Access Compliance Report

Public Rights-of-Way

Intersection ID: 19947	Main Street: CHARTER_PL	Cross Street: THERMAL_RD	Location: SW
ADA ID: EE108333D48B	Ramp Type: ParaDiag	Initial Pass/Fail: Fail	Overall Compliance: No
Codes/Mitigation Info/Possible Solution		Field Measurements/Component Compliance	
Severity Score: 22.5

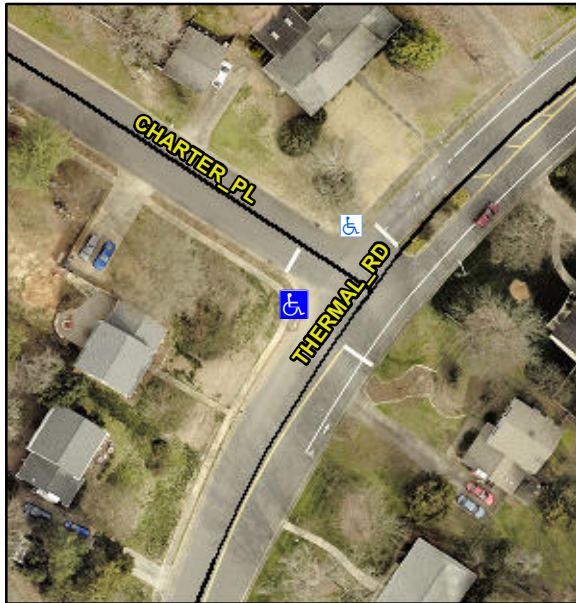
R304.5.1, R304.3.2, R304.5.3

Compliance	Description	Data	Compliance	Description	Data
N/A	Ramp Length LT (in)	55.0	N/A	Ramp Length RT (in)	40.0
No	Ramp Width LT (in)	46.5	Yes	Ramp Width RT (in)	48.0
No	Ramp Slope LT (%)	9.6	Yes	Ramp Slope RT (%)	8.2
No	Ramp XSlope LT (%)	3.5	Yes	Ramp XSlope RT (%)	1.5
N/A	Landing Length (in)	N/A	N/A	DWS Provided?	N/A
N/A	Landing Width (in)	N/A	N/A	DWS Contrast?	N/A
N/A	Landing Slope (%)	N/A	N/A	DWS Length (in)	N/A
N/A	Landing X Slope (%)	N/A	N/A	DWS Full Width?	N/A
N/A	Landing Curb? (Y/N)	N/A	N/A	DWS Offset (in)	N/A
N/A	Shared Landing?	N/A			
N/A	Gutter Ponding?	N/A	N/A	Gutter Slope (%)	N/A
N/A	Gutter Lip Ht (in)	N/A	N/A	Gutter X Slope (%)	N/A
N/A	Painted X Walk1?	No	N/A	Painted X Walk2?	No
	X Walk 1 Direction	To E		X Walk 2 Direction	To NE
N/A	X Walk 1 Width (in)	N/A	N/A	X Walk 2 Width (in)	N/A
	X Walk 1 Slope (%)	4.7		X Walk 2 Slope (%)	1.4
	X Walk 1 X Slope (%)	0.4		X Walk 2 X Slope (%)	2.3
N/A	Ramp inside XWalk1?	N/A	N/A	Ramp inside XWalk2?	N/A

Remove & Replace Curb Ramp With Two New Directional Ramps or Equivalent.
